CITY OF SAN DIEGO
M E M O R A N D U M

DATE: October 15, 2015
TO: Historical Resources Board and Interested Parties
FROM: Kelley Stanco, Senior Planner 
SUBJECT: **ITEM 7 – 1845 29TH STREET**

DATE ISSUED: March 18, 2014 REPORT NO. HRB-14-023

SUBJECT: **ITEM #10 – 1845 29th Street**

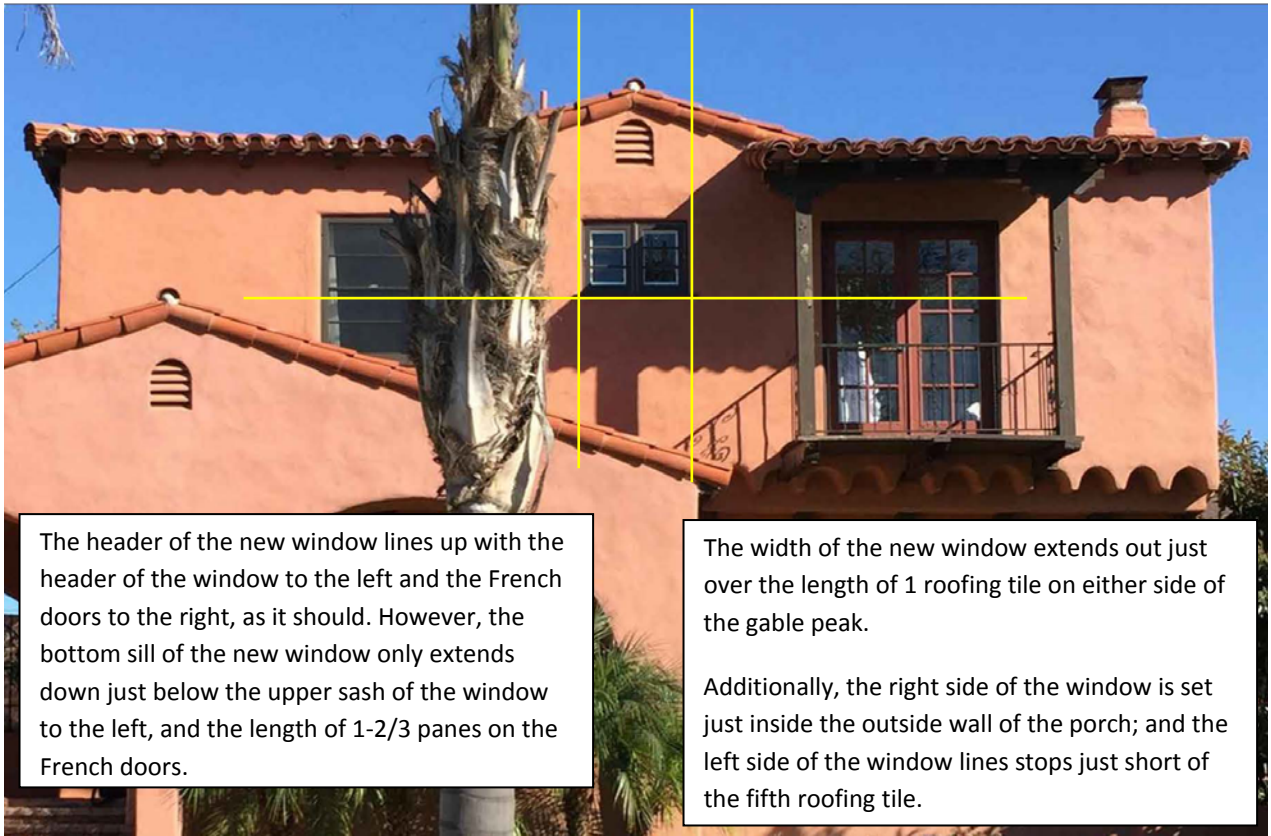
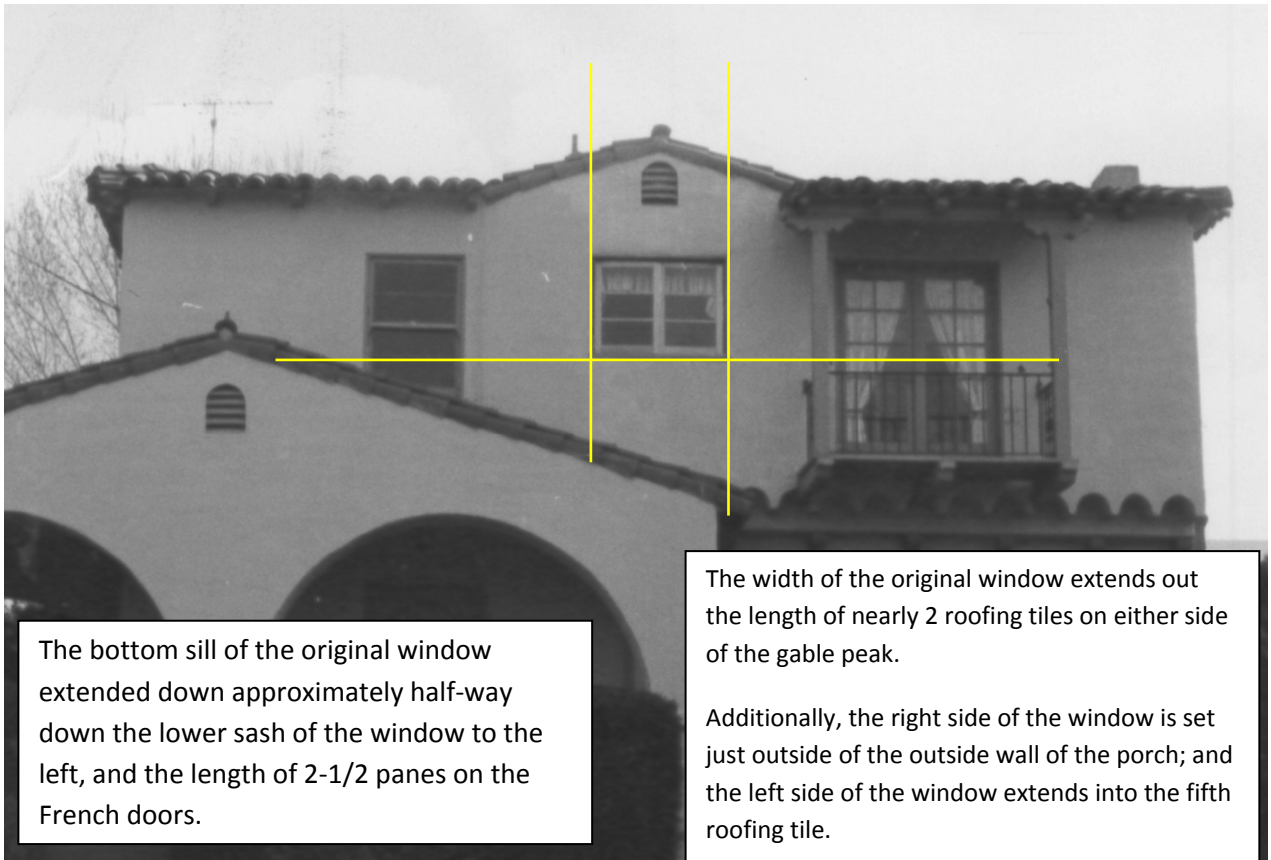
The header of the new window lines up with the header of the window to the left and the French doors to the right, as it should. However, the bottom sill of the new window only extends down just below the upper sash of the window to the left, and the length of 1-2/3 panes on the French doors.

The width of the new window extends out just over the length of 1 roofing tile on either side of the gable peak.

Additionally, the right side of the window is set just inside the outside wall of the porch; and the left side of the window lines stops just short of the fifth roofing tile.

The bottom sill of the original window extended down approximately half-way down the lower sash of the window to the left, and the length of 2-1/2 panes on the French doors.

The width of the original window extends out the length of nearly 2 roofing tiles on either side of the gable peak.

Additionally, the right side of the window is set just outside of the outside wall of the porch; and the left side of the window extends into the fifth roofing tile.

Although the roofing has been replaced since this photograph, the same number of tiles are present along the roof-wall junction, indicating replacement with the same size tile.
